ADA Curb Ramp New Construction Inspection Form (Parallel)

Shadybrook

24952.54

Yorkshire

PARALLEL RAMP (PL)

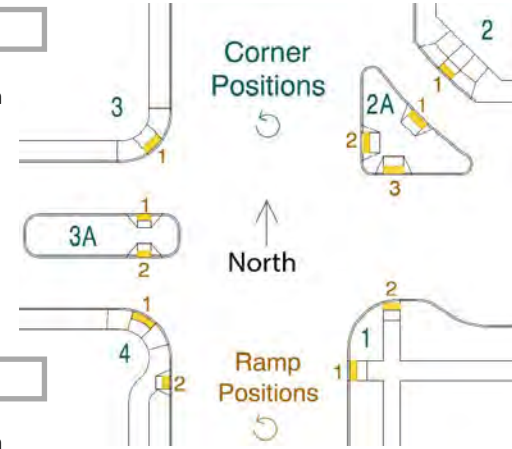
5.4 $\leq 2.0\%$ ☐ $> 2.0\%$ ☒

☐ $\leq 2.0\%$ ☐ $> 2.0\%$ ☒

N Y ☐ N ☒

0.5 $\leq 1/4"$ ☐ $> 1/4"$ ☒

1.6 $\leq |5.0\%|$ ☐ $> |5.0\%|$ ☒

N Y ☐ N ☒

☐ $\leq 8.3\%$ ☐ $> 8.3\%$ ☒

4 $\leq 2.0\%$ ☐ $> 2.0\%$ ☒

☐ $\leq 8.3\%$ ☐ $> 8.3\%$ ☒

5.2 $\leq 2.0\%$ ☐ $> 2.0\%$ ☒

3.65 $\geq 4.0'$ ☐ $< 4.0'$ ☒

5.4 $\leq 2.0\%$ ☐ $> 2.0\%$ ☒

CRK curb & gutt. No td.
